# FINAL DRAINAGE LETTER FOR LOT 1, WOODMEN HILLS FIL NO. 7H

December 2020

# Drainage Letter\_V1.pdf Markup Summary

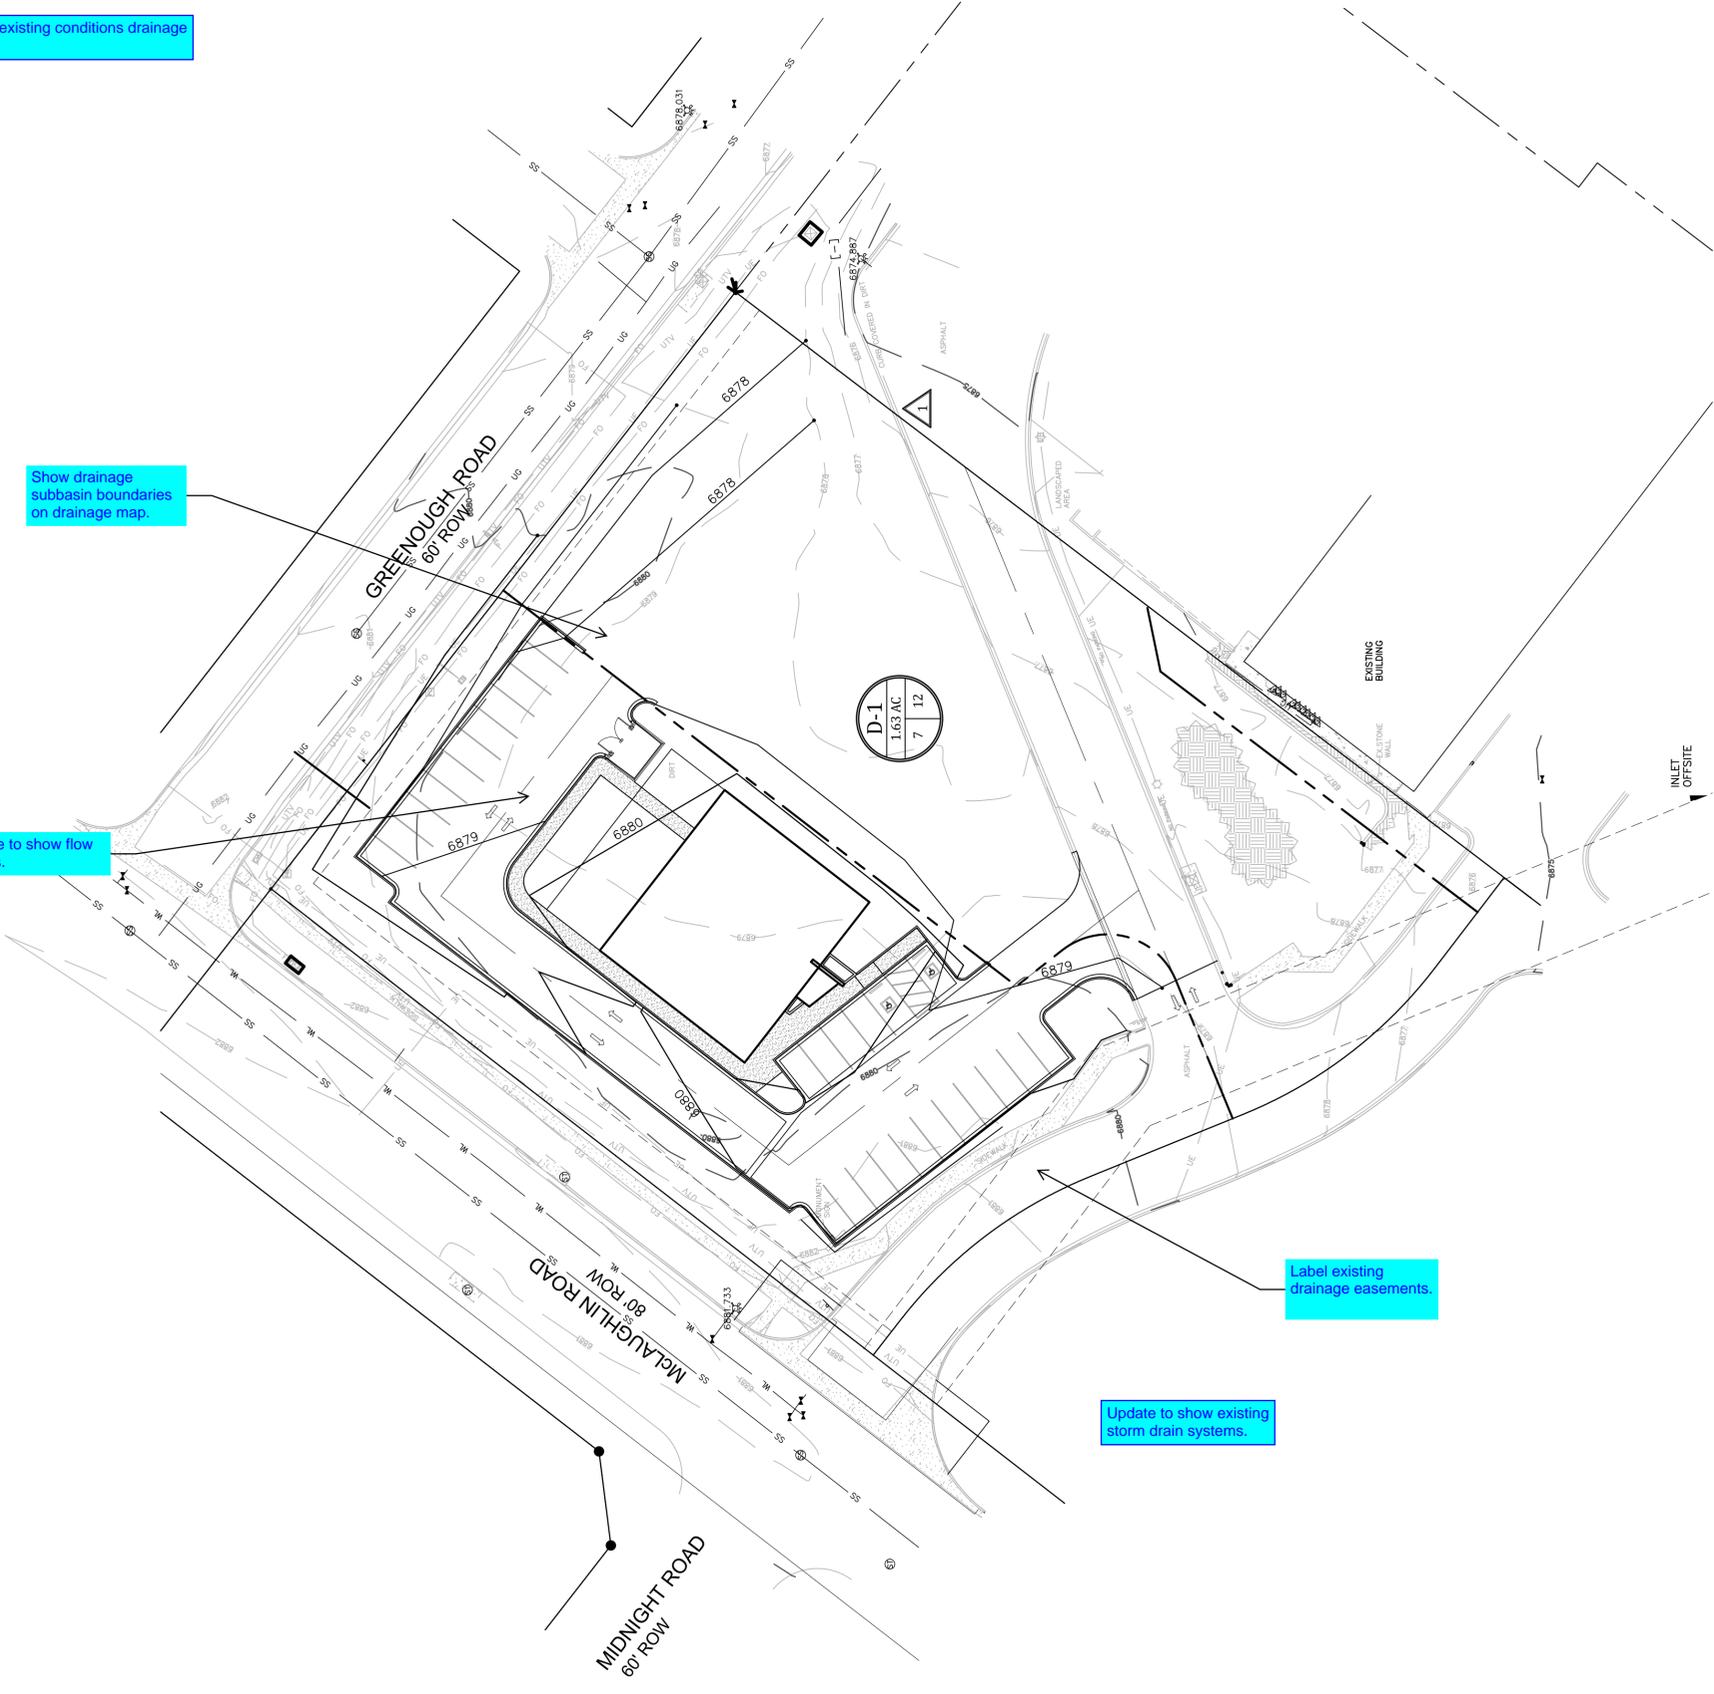
Provide an existing conditions drainage map.

Show drainage subbasin boundaries on drainage map.

Update to show flow arrows.

Label existing drainage easements.

Update to show existing storm drain systems.
